STAFF REPORT AND RECOMMENDATION TO THE DESIGN COMMISSION

CASE FILE: LU 17-252155 DZ
PC # 17-184917
Revisions to Providence Park Stadium Expansion
REVIEW BY: Design Commission
WHEN: December 14, 2017 at 1:30 pm
WHERE: 1900 SW Fourth Ave., Room 2500B
Portland, OR 97201

CONDITION OF APPROVAL E - VIEW SHED

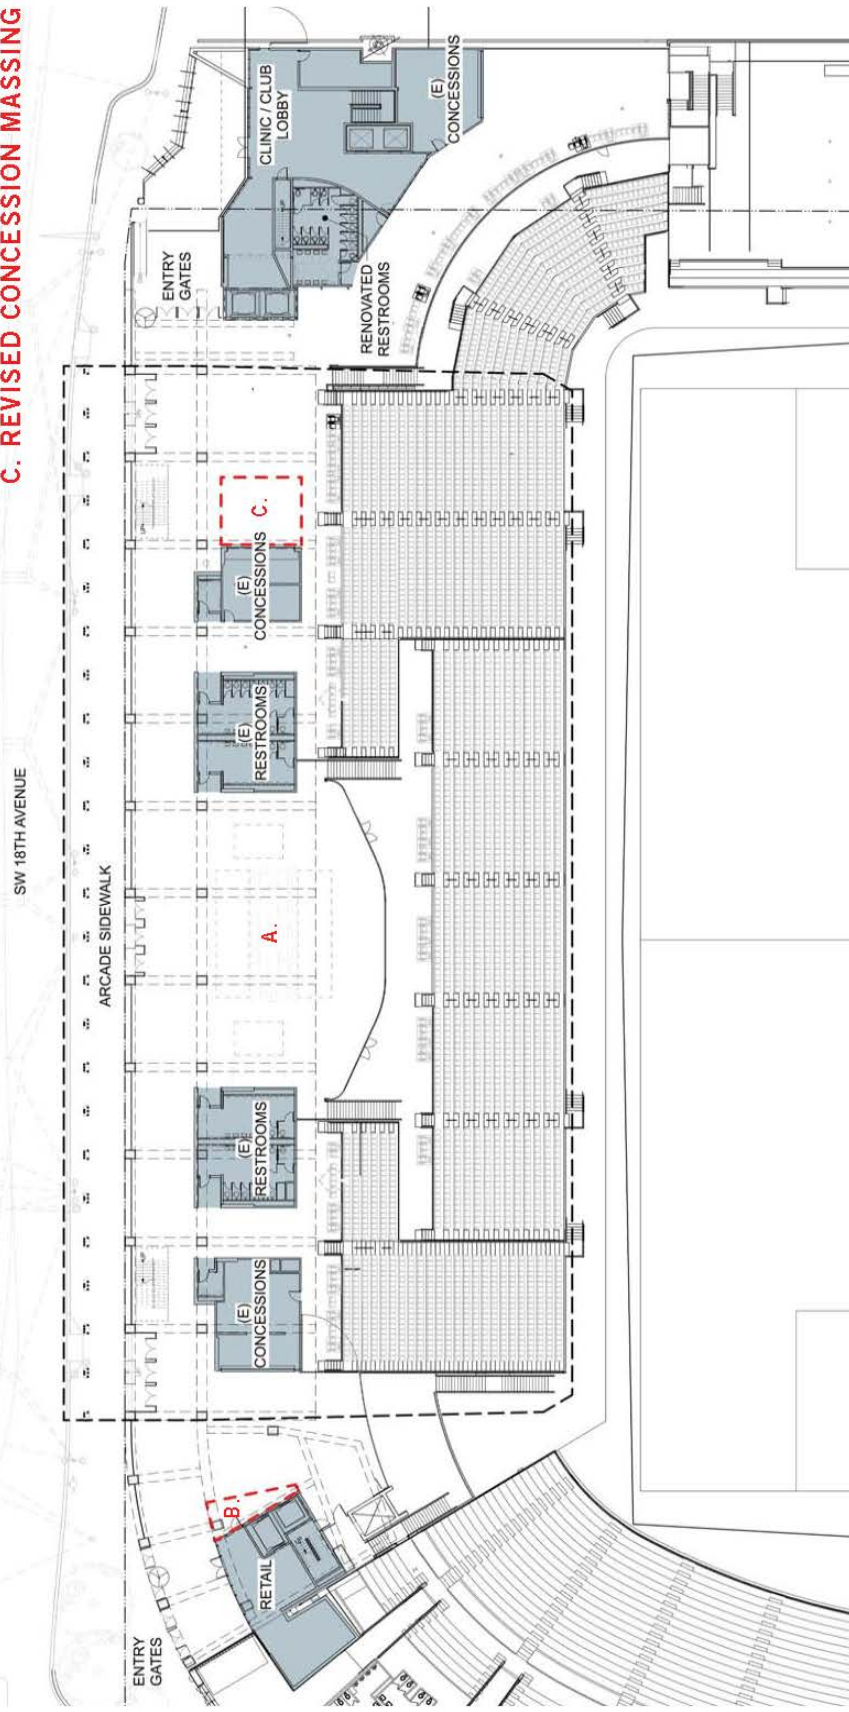
When the original design of the expansion was presented to the Design Commission at the May 11, 2017 Design Advice Request (DAR), the height between the grade level and the bottom of the elevated seating structure was proposed to be 10'-10". At the August 3, 2017 Design Review hearing, the height proposed was 10'-1". Because the height of the original design was not correctly provided during this Design Review hearing, the Design Commission requested a Condition of Approval E that the distance between sidewalk grade to the bottom of the first elevated seating structure shall be a minimum of 11'-3". An alternate to Condition of Approval E is proposed.

To provide the 9-inch increased view shed under the elevated seating structure, the first row of seating would need to be removed. This would be a loss of 160 seats. This is a substantial number of seats considering existing site constraint for any future expansion. Instead of proposing to eliminate 160 seats and increase the view shed height by 9 inches, this alternate is proposing to expand the view sheds at the concourse/ground level of the north and south entryways along SW 18th Avenue and just north and south of the arcade. The significant improvement to views at these proposed locations were made possible through changes of massing of proposed elevator and stair core at the north location, as well as a reduction of restroom square footage requirement in the south location.

The proposed view shed openings at the north and south entryways at the concourse level of the stadium along SW 18th Avenue will have a significant impact on enhancing view opportunities, providing viewing areas at all main entry ways along SW 18th Avenue. Because with these public view sheds guidelines B4 and C1 would be met, staff has added a condition of approval on these three areas of public viewing.

- E. A minimum height of 10'-1" must be maintained from the SW 18th Avenue sidewalk grade to the bottom of the first elevated level seating structure for the full width of the three middle-bay stadium view corridors from SW 18th Avenue. In addition, the view shed openings (A and B) at the north and south entryways at the concourse level along SW 18th Avenue shall be maintained open per Exhibit C.5.
